WATTS BAR NUCLEAR PLANT (WBN) - UNITS 1 AND 2 - RESPONSE TO NRC OPEN ITEMS FROM IN-OFFICE AUDIT OF CIVIL CALCULATIONS (TAC NOS. 500514, M73097, AND M73098)

VALIDITY OF REACTION FORCES AND
ADEQUACY OF THE FINITE ELEMENT MODEL
AT THE BOUNDARY OF THE SLAB

ITEM NO. AU-10

Item No AU-10
 Sheet 2 of 11

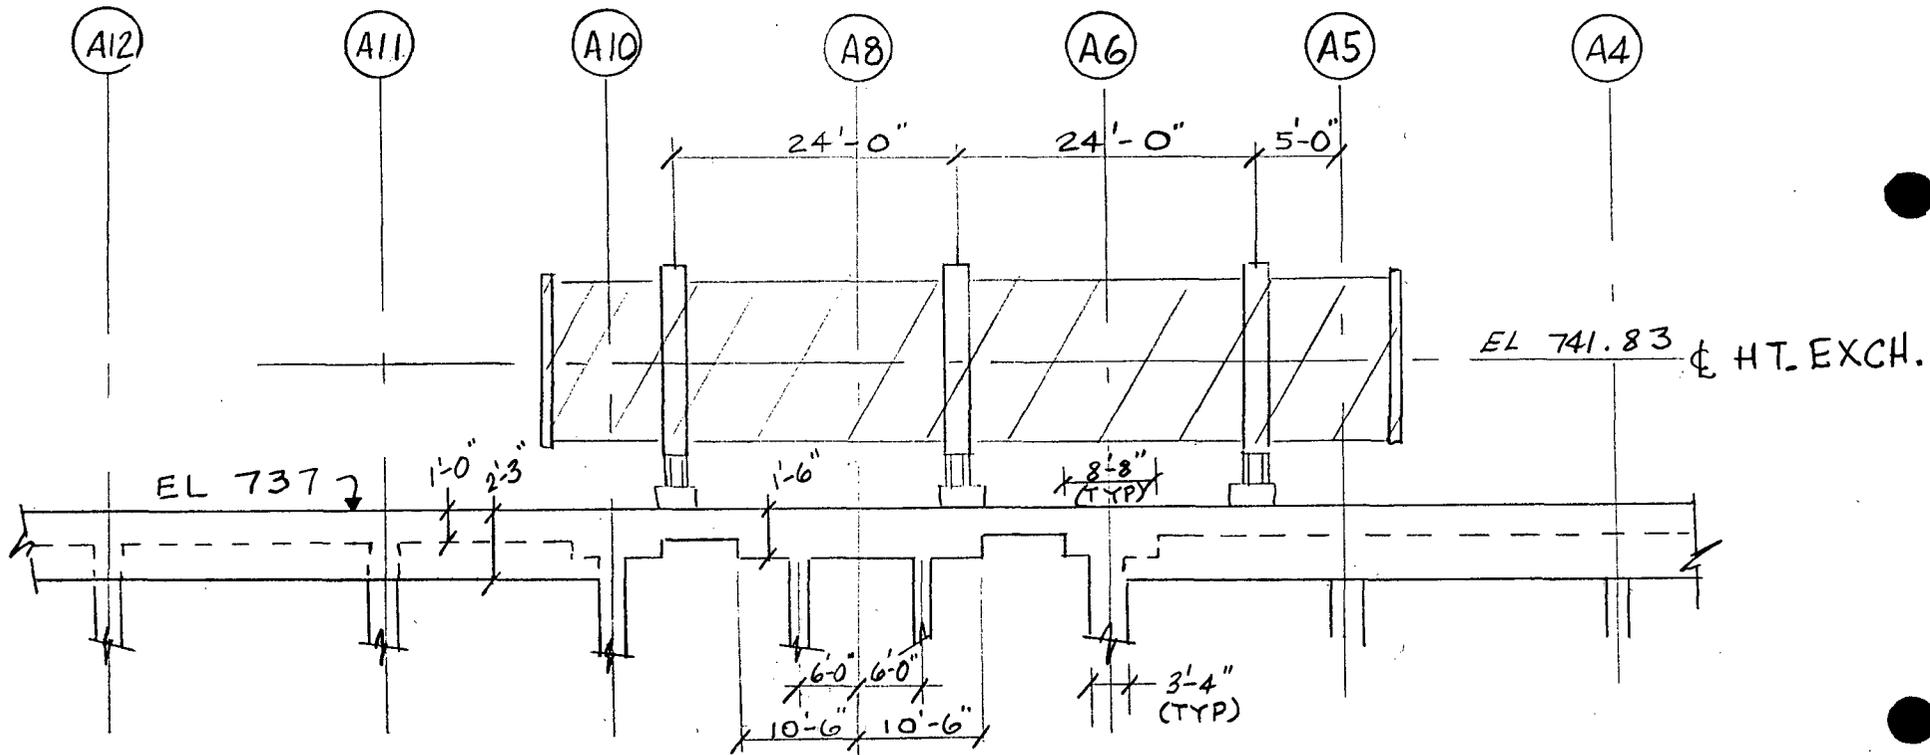
The arrangement of the equipment and the positioning of the columns supporting the one foot slab at elevation 737, as shown on the sketch of attachment for AU-10 sheet 2, was expected to result in the worst slab loading in the region between the Component Cooler Water Heat Exchangers, to the north and south of column line s. The slab model boundaries therefore were extended sufficiently away from the column line s, to column lines "r" and "t". The boundary conditions along the column line "r" are reflecting the presence of a large continuous concrete beam, and the nodes are vertically restrained along this line.

Item No AU-10
 Sheet 3 of 11

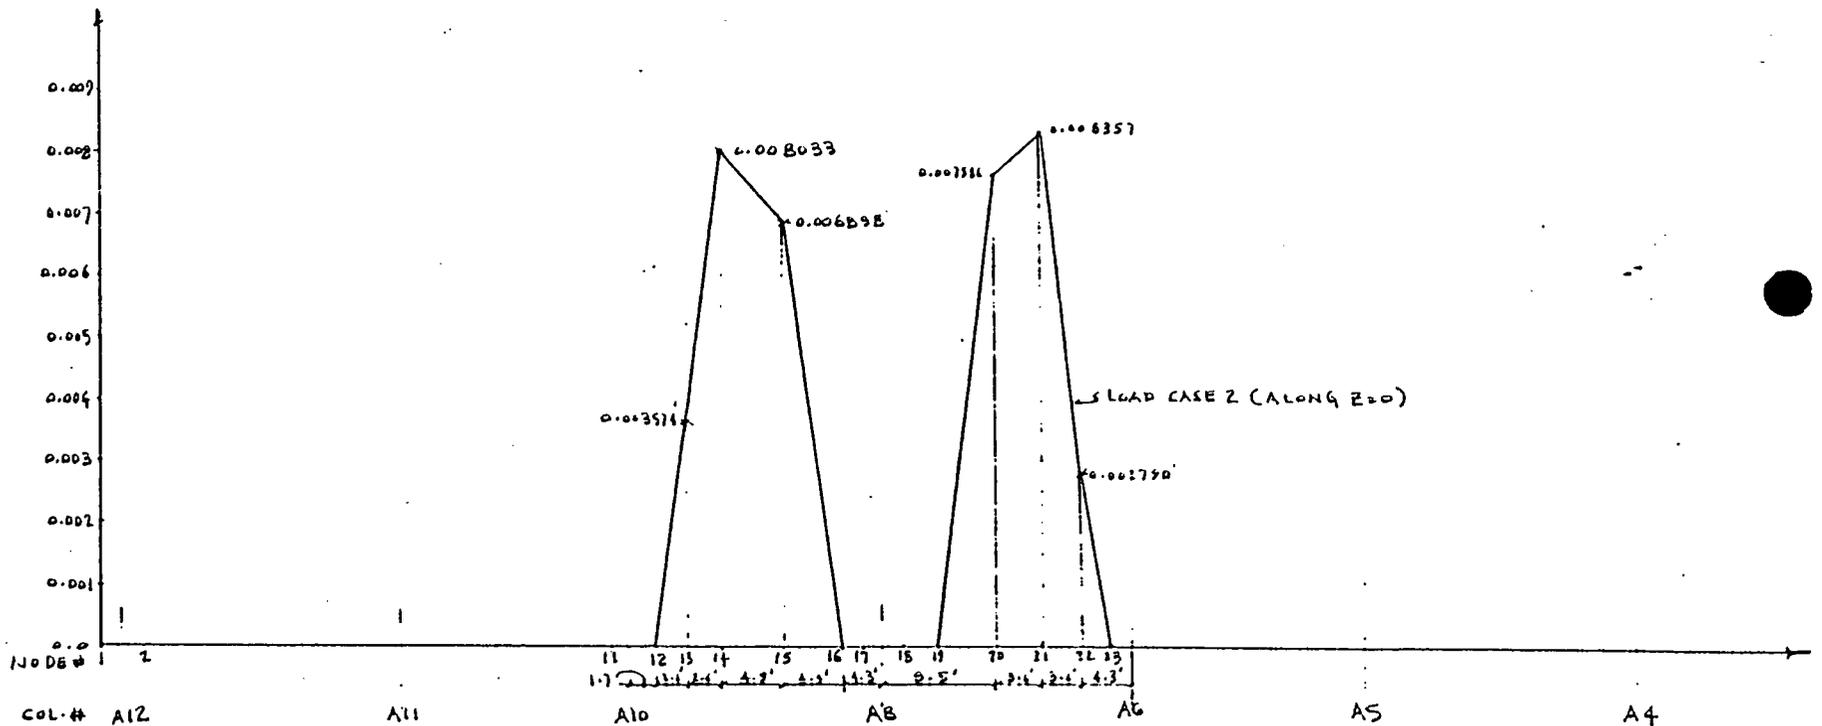
The conditions along the column line t however, consist of a series of slabs of different thicknesses, intersecting walls and drop panels with columns, as shown on the sketch of attachment for AU-10 sheet 3. Conservative idealization of the model was performed at this complex boundary. All but one foot thick slab sections were restrained in the vertical direction, and the one foot slab was freed for conservatism, neglecting the resistance in vertical direction inherent in continuous slabs.

Item No. AU-10
 Sheet 4 of 11

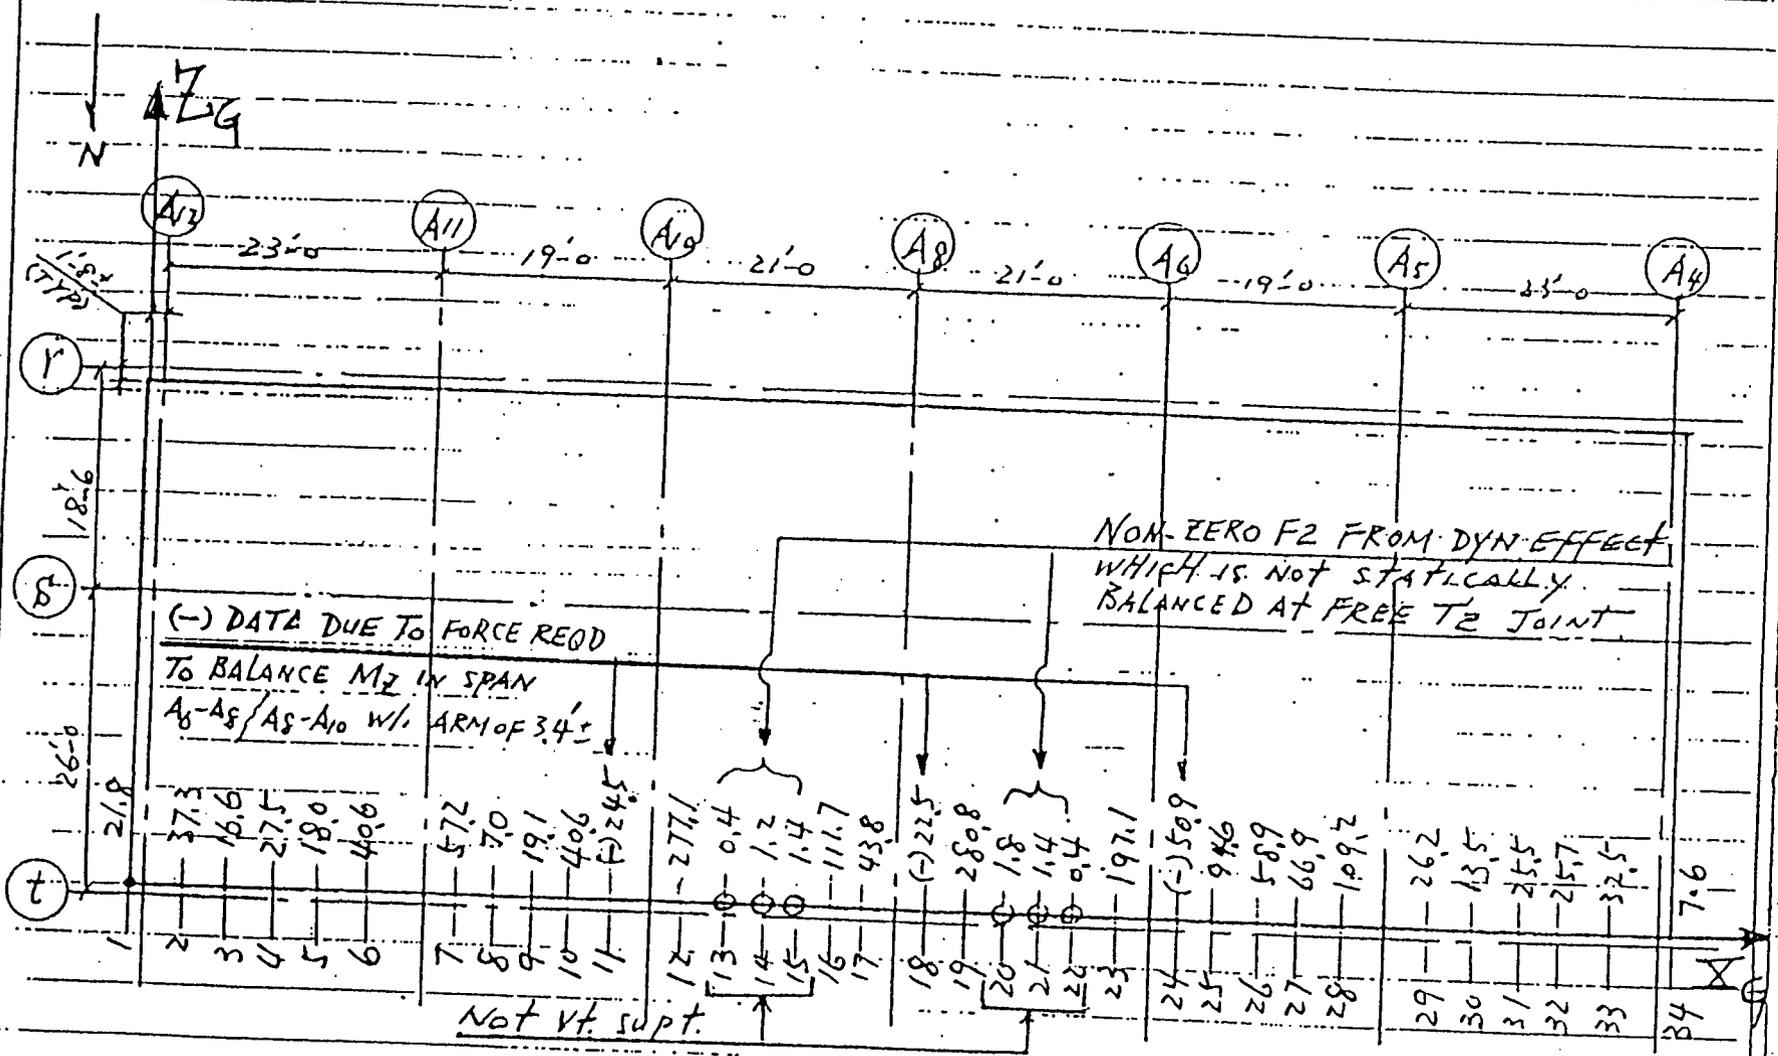
The AU-10 sheet 4 sketch shows a plot of deflections along the boundary, which is reflective of the above phenomena, and the AU-10 sheet 5 sketch provides the reactions along the same boundary. The effects of the idealized model boundary are localized largely in the vicinity of the boundary, and rapidly attenuate with distance. The AU-10 sheet 6 sketch provides a deflected shape along the boundary line at an offset of approximately 4'-0 distance.

Item No. AU-10
 Sheet 7 of 11

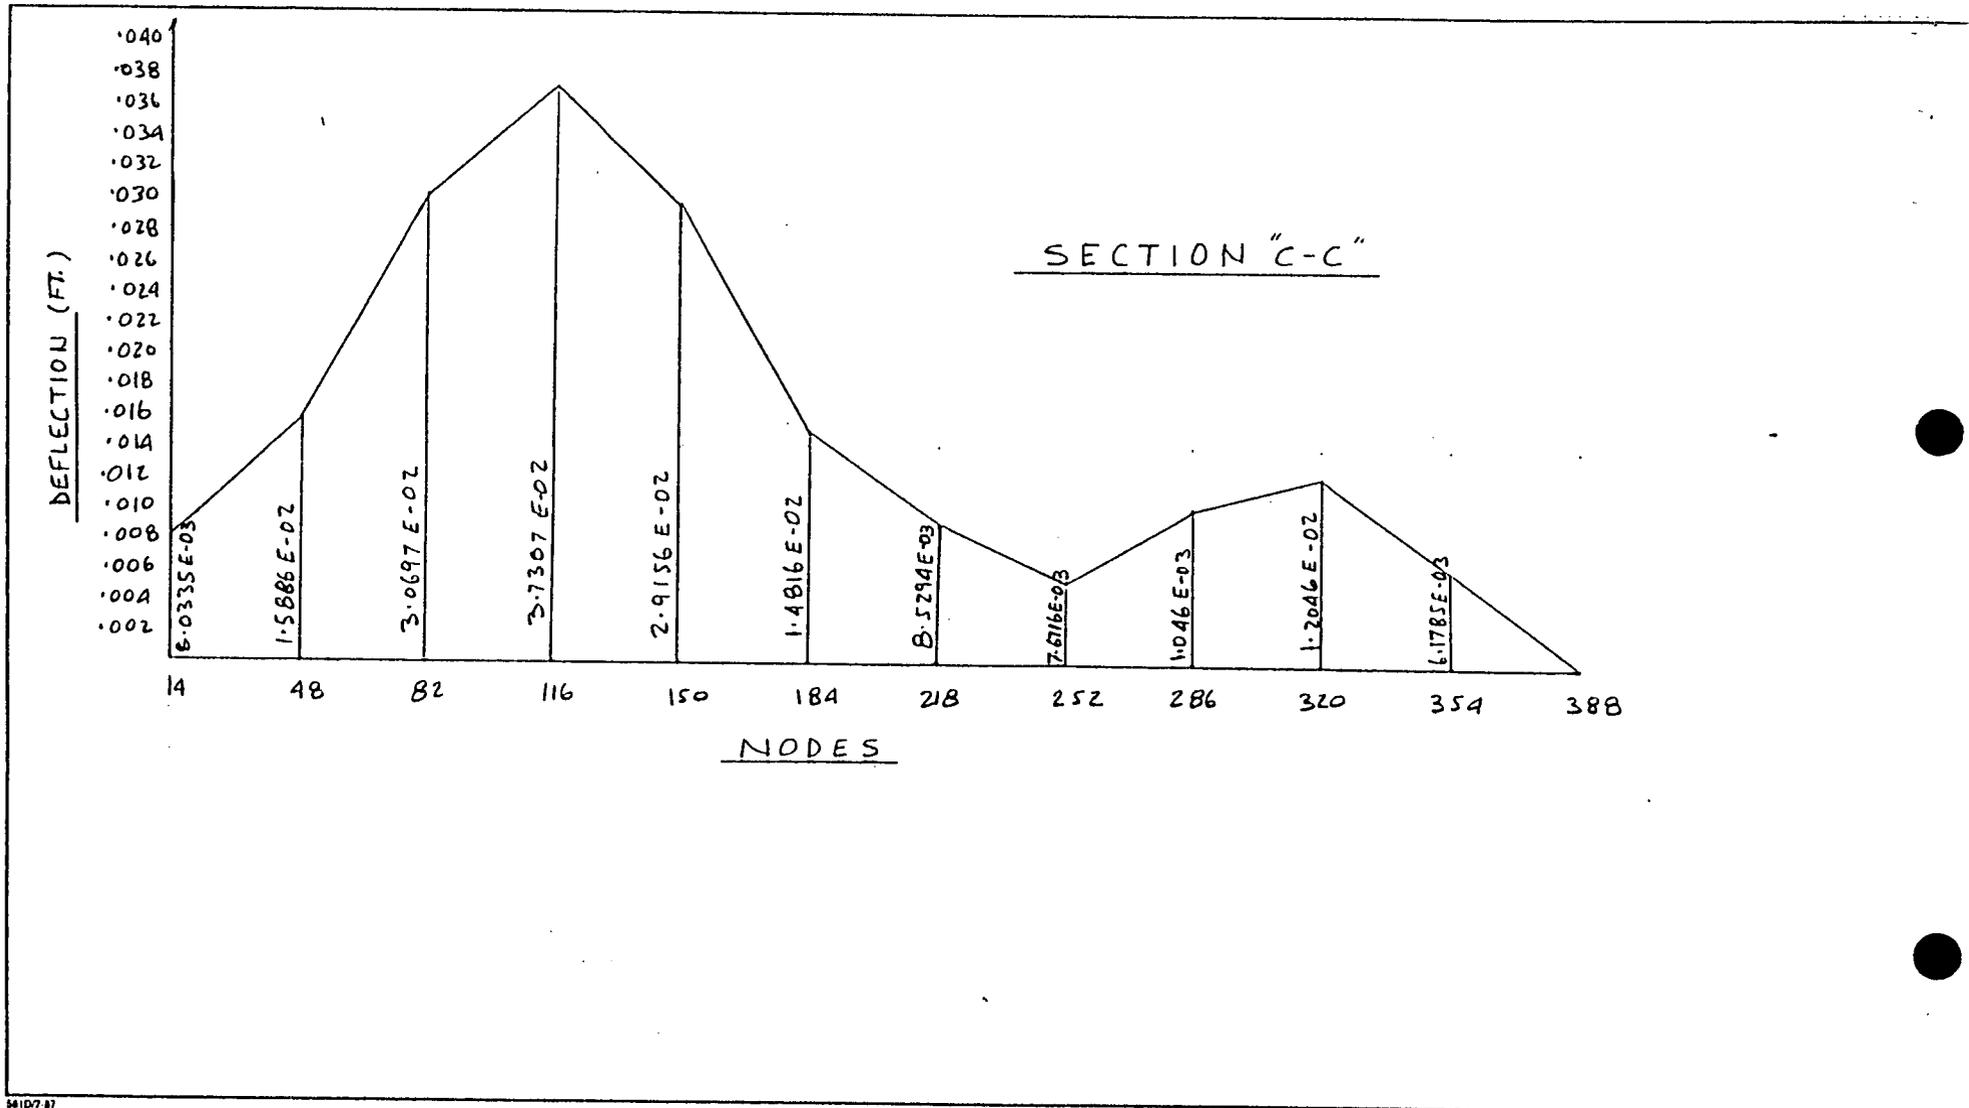
In contrast and as expected the structural behavior of the slab away from the boundary line and in the areas of expected high stress is realistic and accurate. Sheets 7 thru 11 of attachment for AU-10 which provide deflection profiles between column lines "t" and "r", demonstrate this fact.
